# DEPARTMENT OF THE ARMY TECHNICAL BULLETIN

## MAIN ROTOR SYSTEM HARDWARE FOR AH-64 BLADE FOLD KIT

30 June 2004

## TB 1-1520-238-20-135

Fig. 1

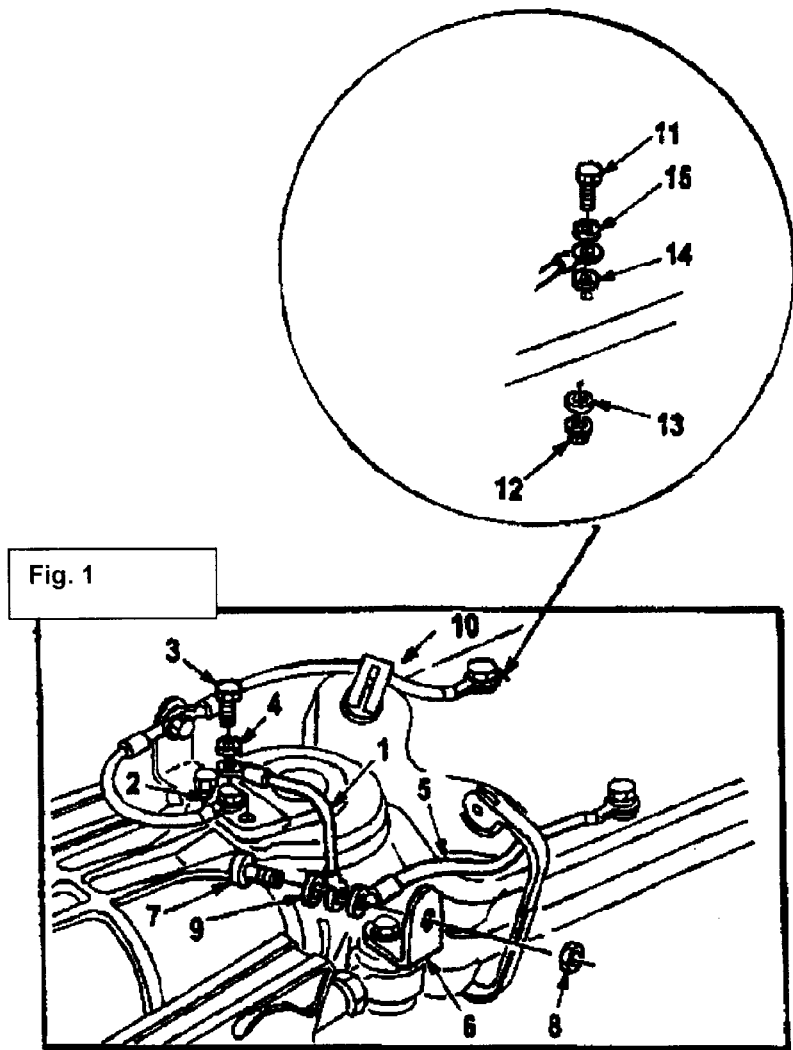
10.3 On each of the 4 main rotor pitch change housings locate the eight 7-211411188 clips referencing (6) (Fig. 1).

10.4 Disassemble the bonding jumper and discard attaching hardware referencing (Fig. 1).

10.8 On each of the 4 main rotor blades locate bond jumper P/N HS5509-11-DE-3 and attaching hardware referencing bolt (11), washer (15), lead (5), washer (14 and 13) and nut (12) (Fig. 1).

10.9 Remove and discard bond jumper P/N HS5509-11-DE-3 and attaching hardware referencing bolt (11), washer (15), lead (5), washer (14 and 13) and nut (12) (Fig. 1).

Fig. 3

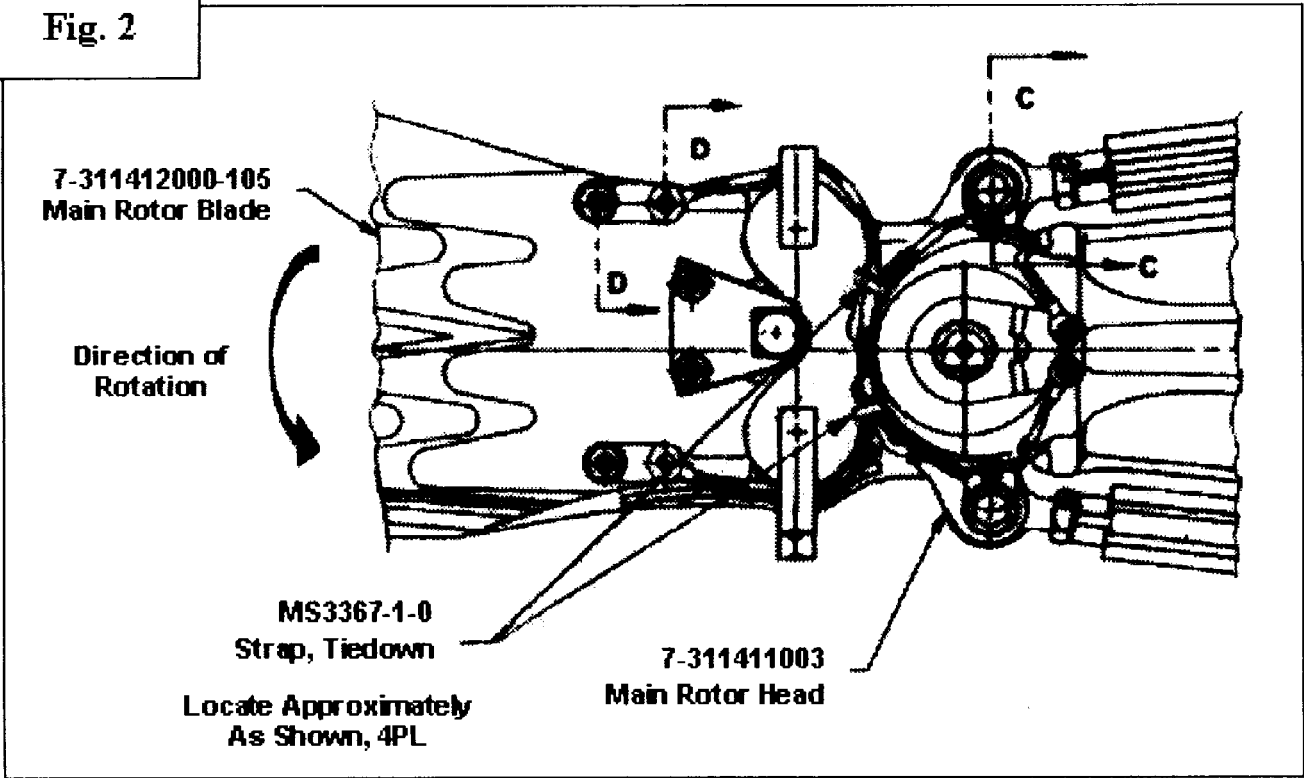
10.7 Attach bond jumper P/N HS5509-18E-3 along with the existing bond jumper P/N MS25083-2DD7 using, bolts, NAS1306-2, washers NAS1149D0663J, and nuts MS21042L6 referencing (Fig. 3). Torque nuts, MS21042L6, to 60-85 inch-pounds.

10.10 Install bolts, MS21250-06050, upper bushing anchors, 7-311412116-1, clips, P/N 7-311412119-1, lower bushing anchors, 7-311412117-1, washers, NAS1149C0663R, and nuts, HS262-624 referencing (Fig. 3). Ensure the clips are positioned per (Fig. 2) Torque nuts, HS262-624, to 360-390 inch-pounds.

10.11 Install bolts, NAS1306-2, washers, NAS1149D0663J, nuts, MS21042L6, bonding jumper, HS5509-18-DE-3, to clips 7-311312119-1 referencing (Fig. 3). Torque nuts, MS21042L6 to 90-110 inch-pounds.

10.12 Route bond jumper P/N HS5509-18-DE-3 referencing (Fig. 2). Attach other end of the bond jumpers P/N HS5509-18-DE-3 to the clips P/N 7-311412119-1 using kitted hardware, (Fig. 3).

10.14 Perform class S electrical bond check per HP14-30 or MIL-STD-464 between the 7-211411188 clip and the 7-311412119-1 bracket referencing (Fig. 3 and 4).
